CITY OF CODY
PLANNING, ZONING, AND ADJUSTMENT BOARD
TUESDAY December 17, 2019
CITY HALL COUNCIL CHAMBERS @ 12:00 NOON

MEETING DATE:	DECEMBER 17, 2019	TYPE OF ACTION NEEDED	
AGENDA ITEM:		P&Z BOARD APPROVAL:	X
SUBJECT:	SITE PLAN REVIEW: WALMART PICKUP AREA. SPR 2019-22	RECOMMENDATION TO COUNCIL:	
PREPARED BY:	TODD STOWELL, CITY PLANNER	DISCUSSION ONLY:

MEETING DATE:	DECEMBER 17, 2019	TYPE OF ACTION NEEDED	
AGENDA ITEM:		P&Z BOARD APPROVAL:	
SUBJECT:	PLAT AMENDMENT—COOK MINOR SUBDIVISION. SUB 2019-10	RECOMMENDATION TO COUNCIL:	X
PREPARED BY:	TODD STOWELL, CITY PLANNER	DISCUSSION ONLY:

MEETING DATE:	DECEMBER 17, 2019	TYPE OF ACTION NEEDED	
AGENDA ITEM:		P&Z BOARD APPROVAL:	X
SUBJECT:	SITE PLAN REVIEW: ADIDAS/YEEZY CODY SAMPLE LAB. SPR 2019-23	RECOMMENDATION TO COUNCIL:	
PREPARED BY:	TODD STOWELL, CITY PLANNER	DISCUSSION ONLY:

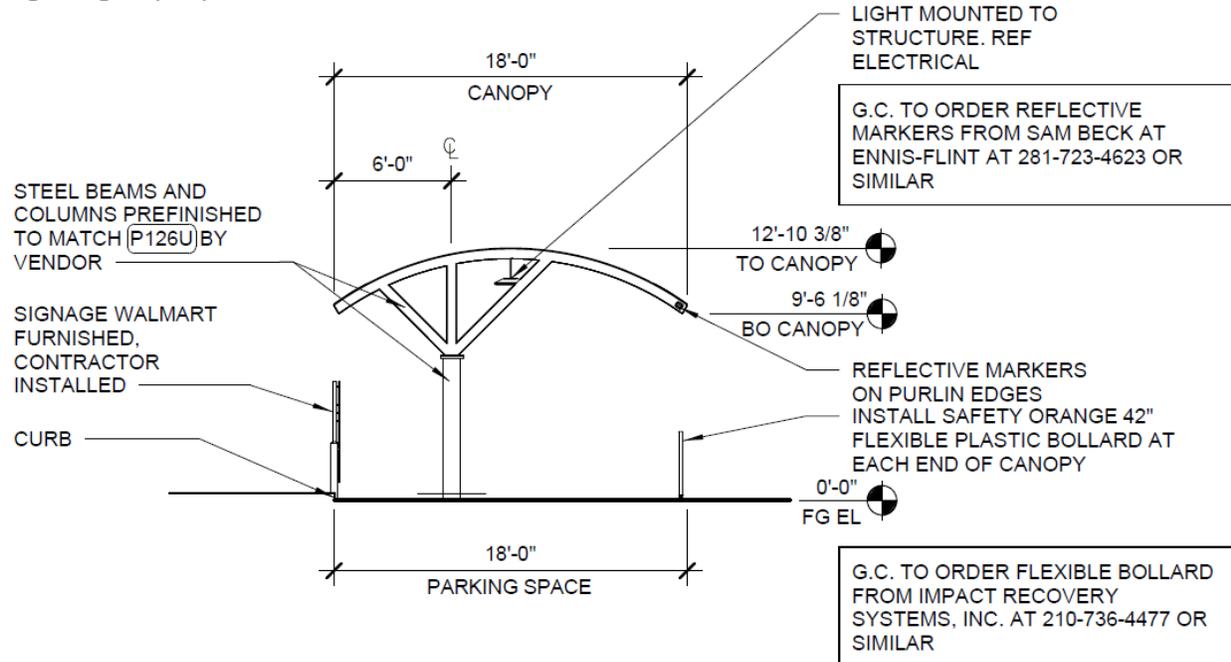
Storm Water:

The canopy does not increase impervious surface or significantly modify drainage. The existing stormwater system is adequate to cover this project.

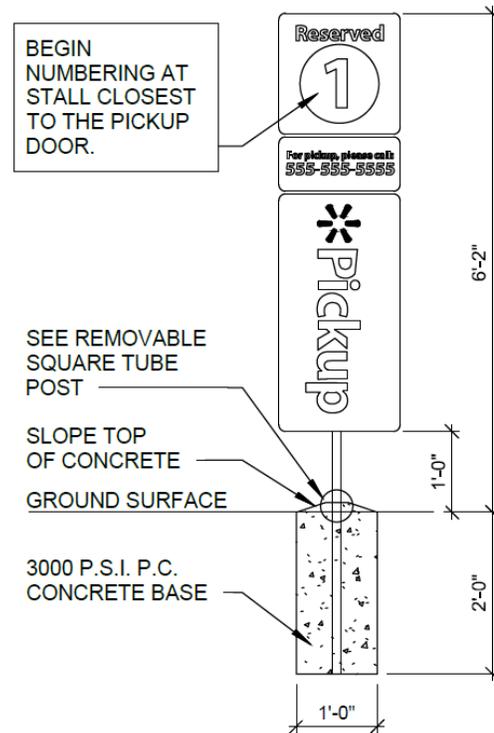
The pickup spaces will each have a sign like the one below. The signs are classified as “convenience signs” and are exempt from the standard sign calculations for size, etc. since they are meant to be viewed only from within the property. The signs in the canopy spaces meet clearance requirements for the sidewalk, etc. The signs on the four east parking spaces appear to be proposed directly over the top of a 12” irrigation pipe and perhaps some TCT lines. Staff has suggested that the signs on the four east parking spaces simply be mounted on the adjacent fence, so that there are no utility conflicts with the sign installation. As of the time of the staff report, we are awaiting the applicant’s decision on placement of those signs. If they are not mounted on the fence, they will need to be installed immediately next to the fence, so that the base does not extend more than one foot from the fence.

Approve the site plan, subject to the following modification: Install the four signs for the east pickup spaces either on the fence, or immediately next to the fence so that the base does not extend more than one foot from the fence.

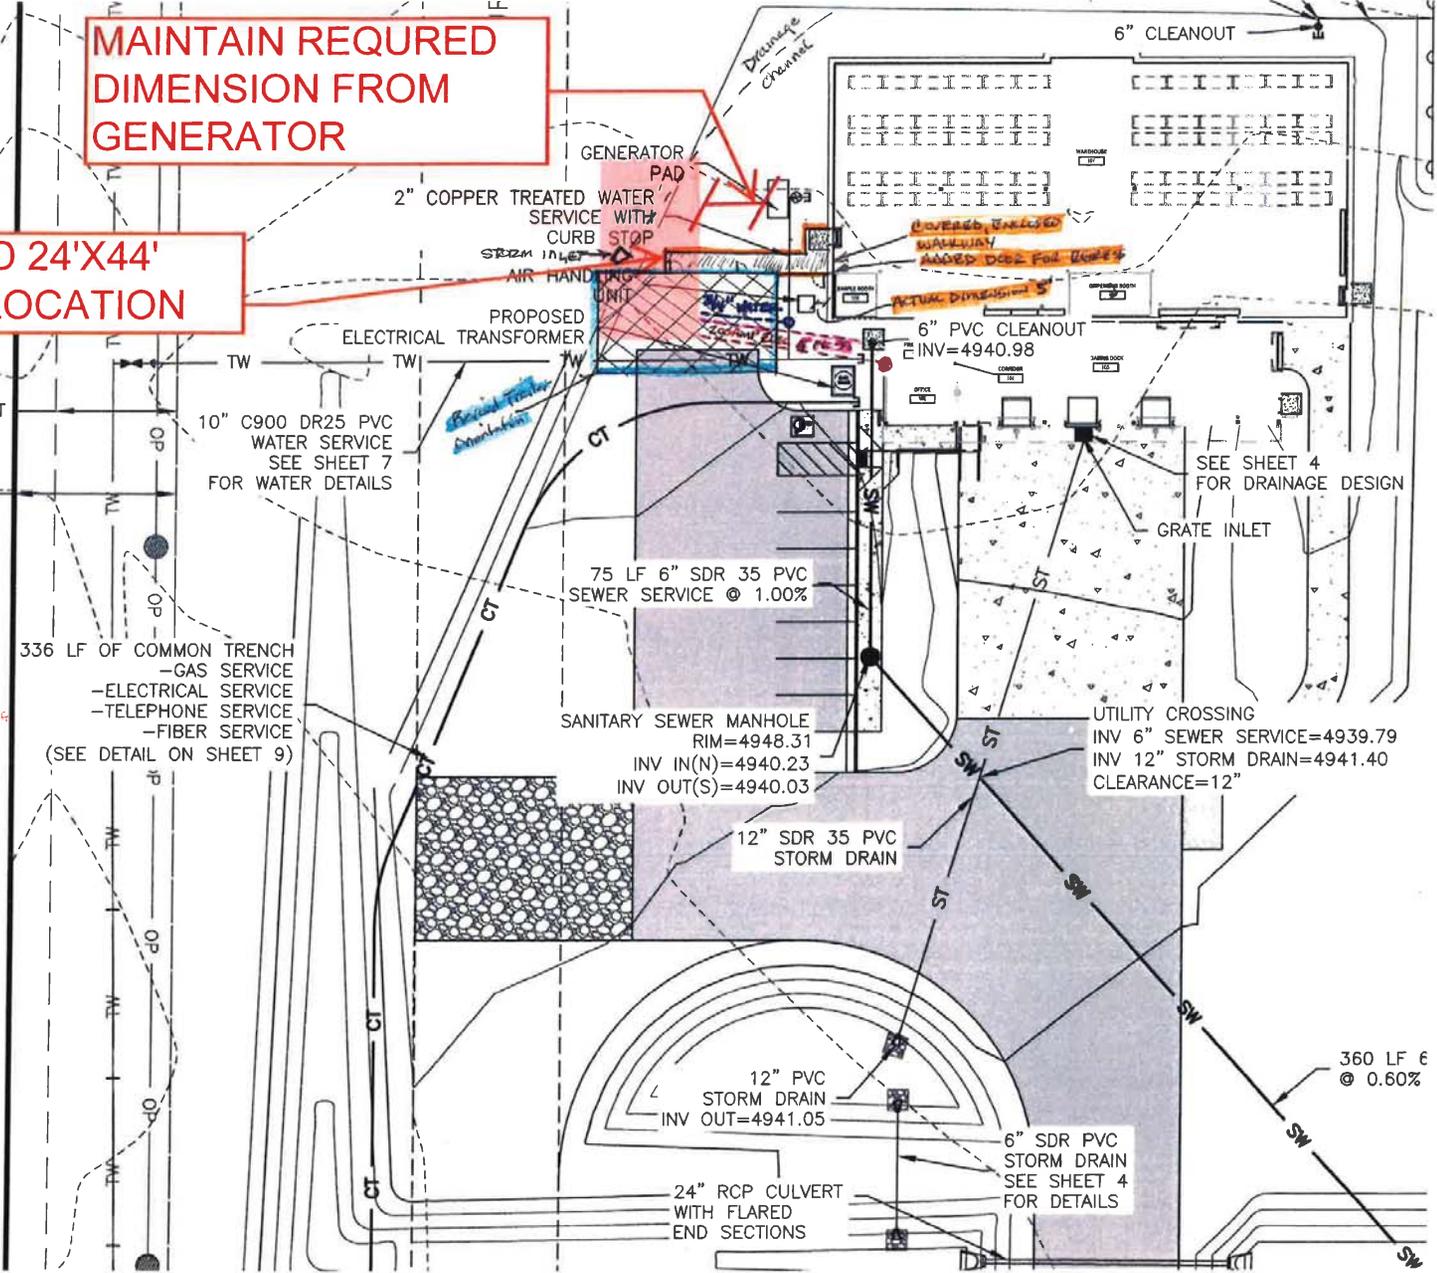
The paved parking area has a capacity of approximately nine vehicles. The proposal is to add seven new spaces in the loading dock area. The area can meet applicable parking standards as shown, with a slight modification of shifting the spaces a couple of feet away from the building.

The modular will be able to drain into the existing stormwater system, which has sufficient capacity for the increased impervious area. The location of the modular has been shifted to avoid disrupting an existing storm inlet.

Upsizing of the transformer (75 kVA to 225 KVA) is needed and is being coordinated with the Electric division. Due to order lead times, the applicant should pay the electrical estimate as soon as possible.

Sewer service for the modular building will tie into a 6" sewer line just to the east.

Water service for the modular is planned to tap an existing line somewhere after the existing water meter, so that an additional meter is not needed. The tie-in point will likely be just within the warehouse building. A ¾" water line will be run to the proposed modular building.

2. Start the striping of the new parking spaces a few feet from the building to allow full functionality of the space closest to the building.
3. Coordinate utility connections and fees with the City—a utility permit is needed.
